Technical Review Committee Meeting

August 2, 2023

2. Conditional Use Permit #23033: 5500 through 6000 Gulf Boulevard (Tradewinds Resort)

Drainage Plan Review Checklist – Conditional Use Permit #23033 – Tradewinds Resort Redevelopment

SAE Turning Radius Calculations for Quote No. 107629

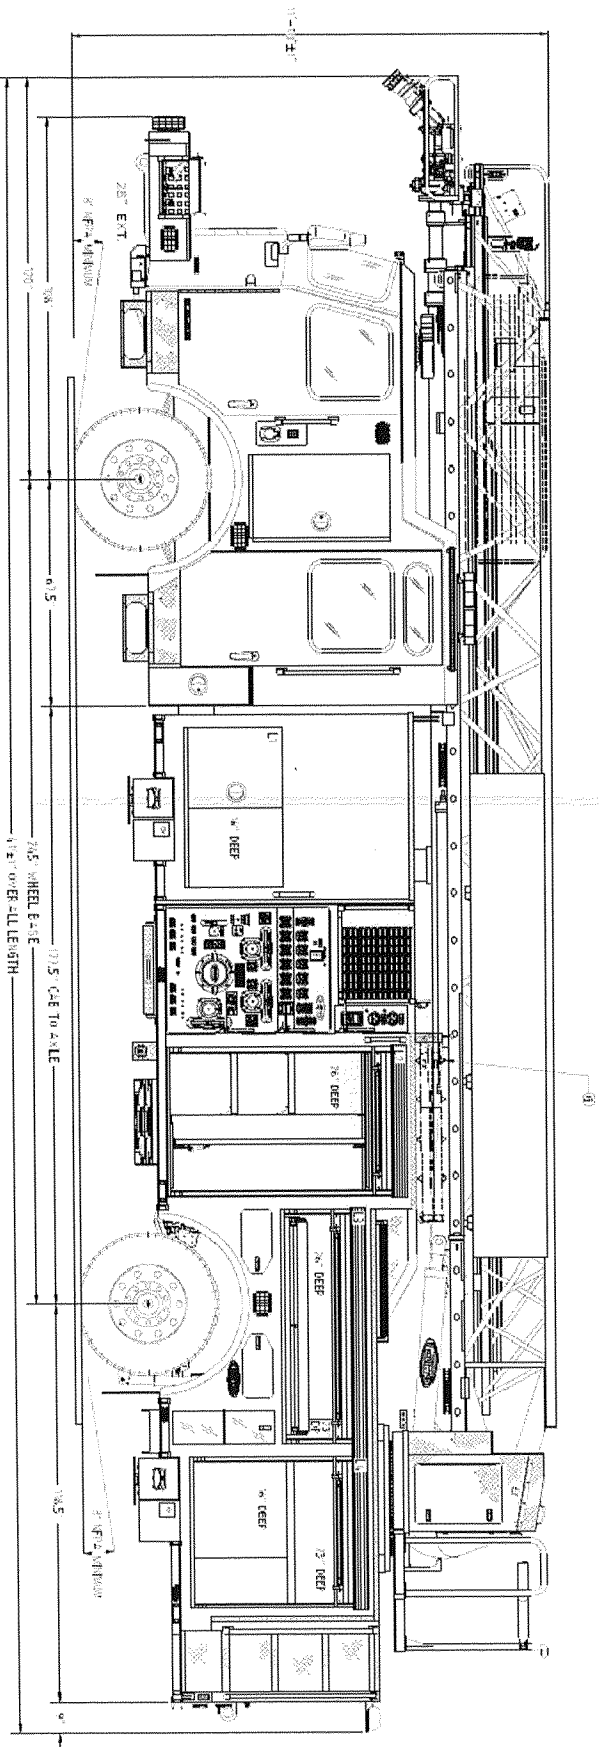
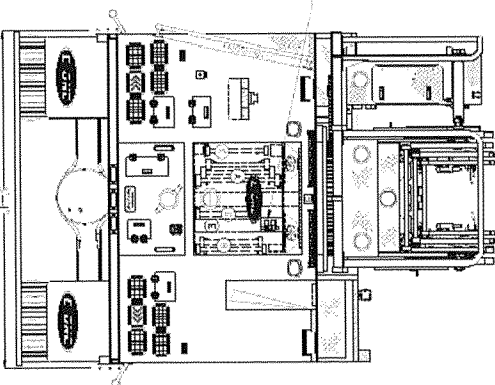
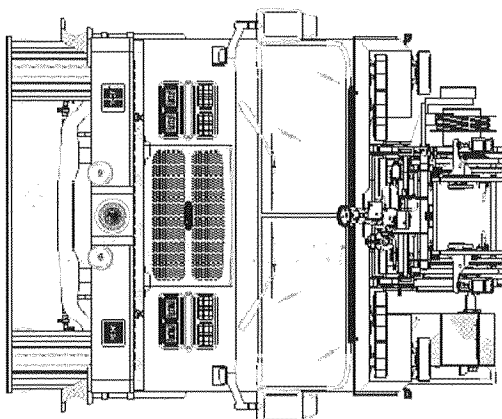
- Provide fire truck maneuverability exhibit reflecting turning radii and drive aisle widths to include fire access road in front of Hotel 3. (NFPA 1: 18.2.3.5.3, 18.2.3.5.1)

FD vehicle movement exhibit (page EX-01)

- T23 specs attached.
